# **Grandstream Networks, Inc.**

## **Request for Class II Permissive Change**

FCC ID: **YZZGXE5102**

*Original mainboard photo view*

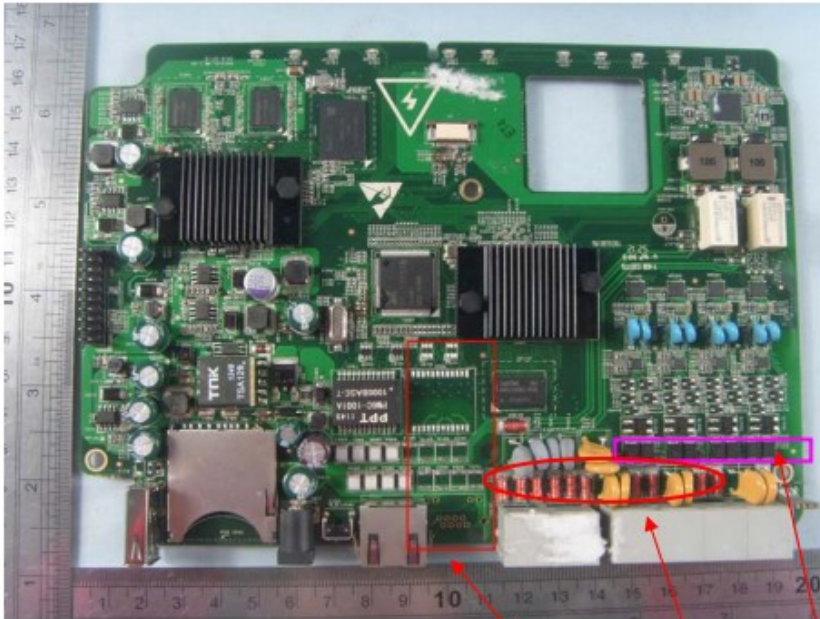
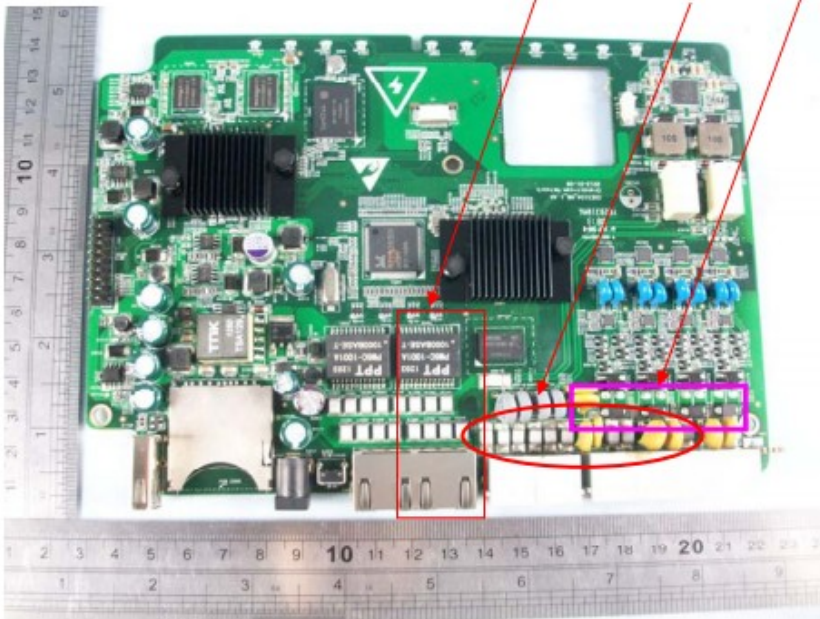
1. Add one power adapter (Model: F18W8-120150SPAU) and has the same electrical specification with original power adapter
  2. Updated model number; changed GXE5104 to UCM6104, GXE5102 to UCM6102;
  3. Added an LAN port on original main board reserved location and four surge protectors tube (See Arrow 1);
  4. Used four high voltage protectors to replace original eight surge protectors (See Arrow 2).
  5. Used ten white surge protectors tube to replace original eleven surge protectors tube (See Arrow 3).
- Anything else are the same as before.
